<b>COMMITTEE OF ADJUSTMENT REPORT SUMMARY MINOR VARIANCE APPLICATION FILE NUMBER A252/21</b>
---	--

<b>AGENDA ITEM NUMBER: 4</b>	<b>CITY WARD #: 3</b>
<b>APPLICANT:</b>	Luciana Campoli
<b>AGENT:</b>	Gregory Sant
<b>PROPERTY:</b>	206 Via Teodoro, Woodbridge
<b>ZONING DESIGNATION:</b>	The subject lands are zoned RD2 9(1279) and subject to the provisions of Exception under By-law 1-88 as amended
<b>VAUGHAN OFFICIAL PLAN (2010) DESIGNATION:</b>	Vaughan Official Plan 2010 ('VOP 2010'): "Low-Rise Residential"
<b>RELATED DEVELOPMENT APPLICATIONS:</b>	None
<b>PURPOSE OF APPLICATION:</b>	Relief from the Zoning By-law is being requested to permit the construction of a proposed covered concrete deck and walkout stairs (to basement) to be located in the rear yard.

## COMMITTEE OF ADJUSTMENT REPORT MINOR VARIANCE APPLICATION A252/21

SITE PLAN

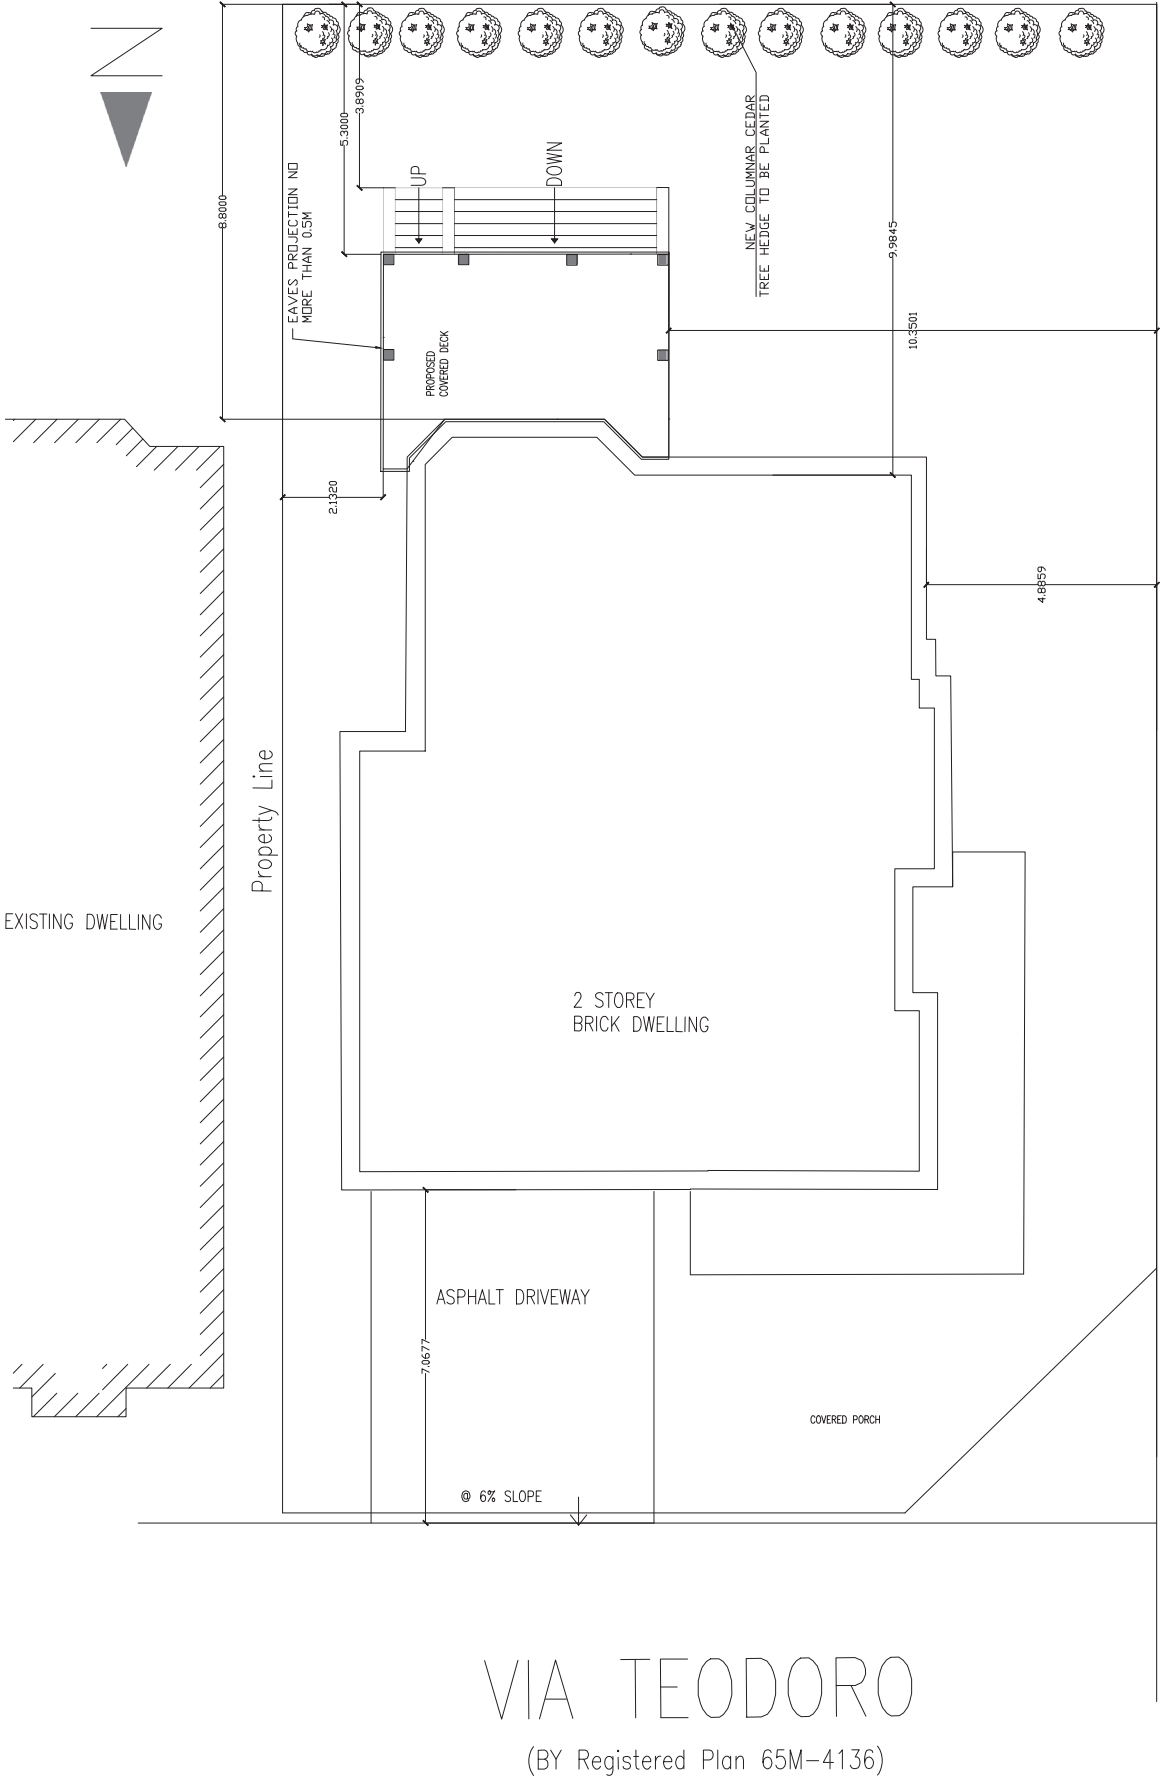
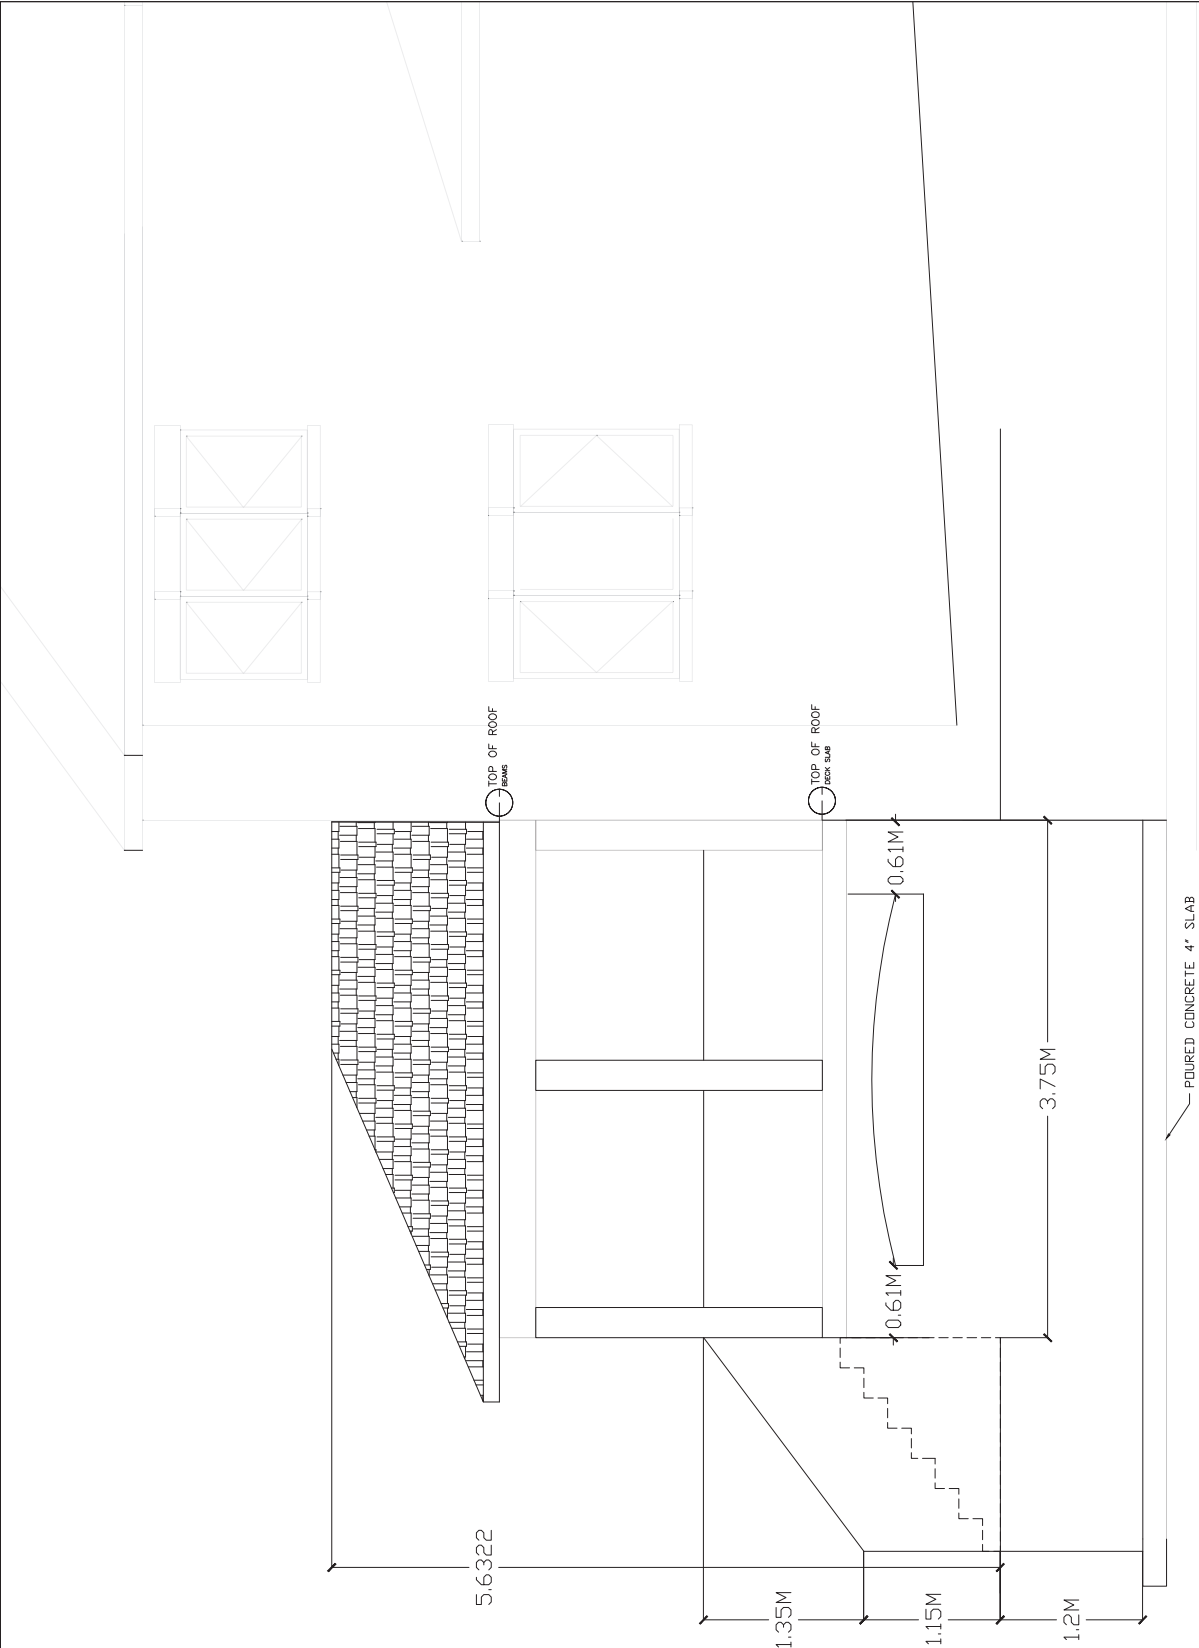
The Owner is proposing to construct a covered deck and stairs in the rear yard with the above-noted variances.

Following discussions with Development Planning staff, the Owner has revised their application, decreasing the maximum rear yard encroachment of the proposed porch and stairs from 4.2 m to 3.61 m, and increasing the minimum rear yard setback to the covered porch from 4.71 m to 5.3 m.

The Development Planning Department has no objection to Variances 1 and 2. The proposed covered porch is 5.63 m in height and covers approximately half the width of the dwelling. The revised variances for the maximum encroachment of the porch and stairs and the rear yard setback to the porch will not negatively impact the adjacent properties and is consistent with previous approvals for rear yard covered porches in the neighbourhood. The Owner is also proposing to plant cedar hedges along the rear property line which will visually screen the structure from the abutting rear neighbour.

Accordingly, the Development Planning Department is of the opinion that the proposal is minor in nature, maintains the general intent and purpose of the Official Plan and Zoning By-law, and is desirable for the appropriate development of the land.

The Development Planning Department recommends approval of the application.
